## PIC18F87J11 Family Silicon Errata and Data Sheet Clarification

The PIC18F87J11 family of devices that you have received conform functionally to the current Device Data Sheet (DS39778E), except for the anomalies described in this document.

## 64-Pin TQFP

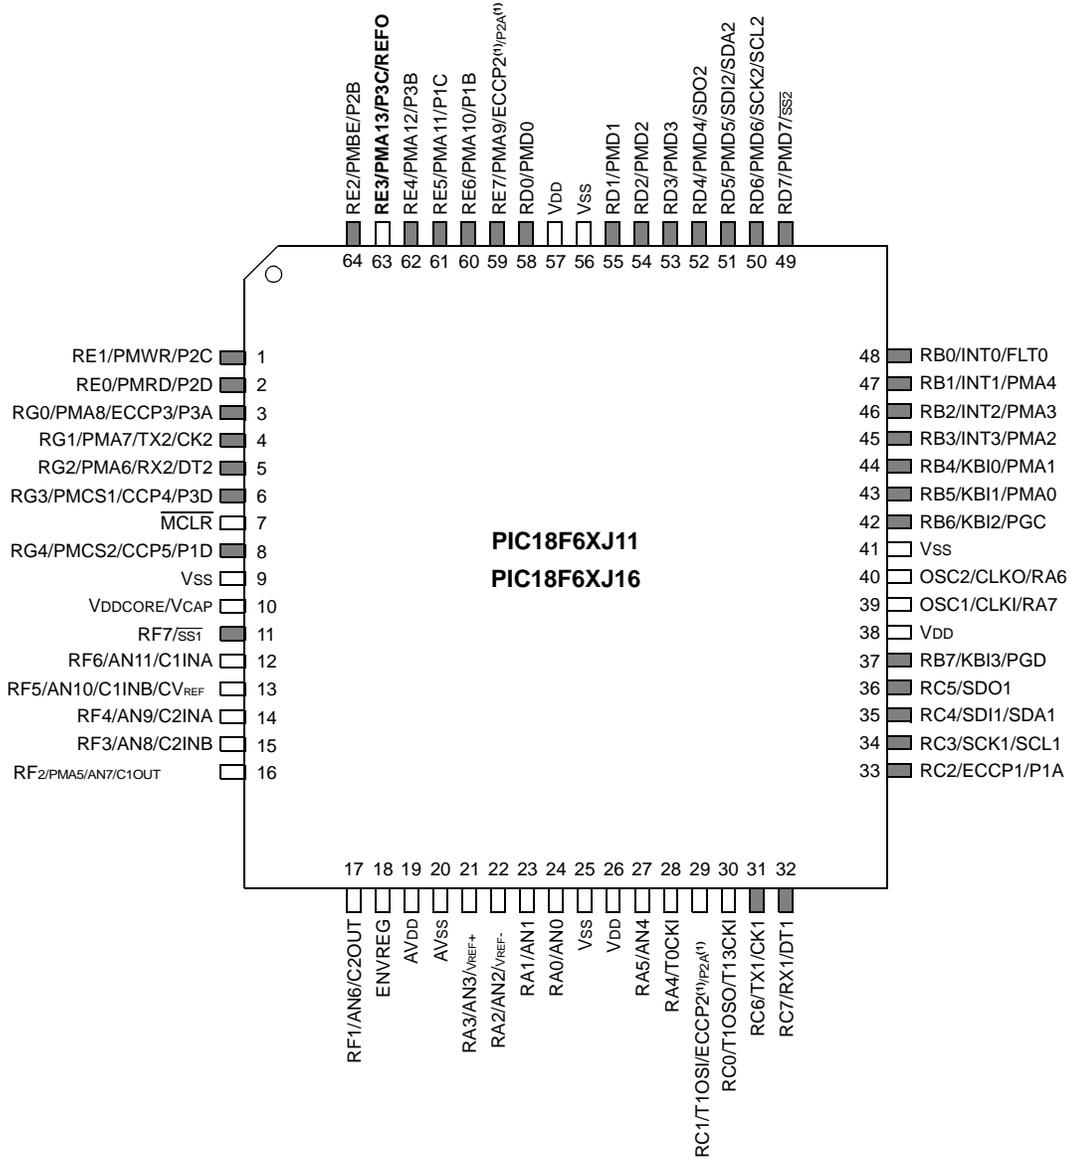
PORTE pin RE3 is not +5.5V tolerant as indicated in the data sheet. The pin diagrams should be corrected to read as follows:

**Legend:** Shaded pins indicate pins that are tolerant up to +5.5V.
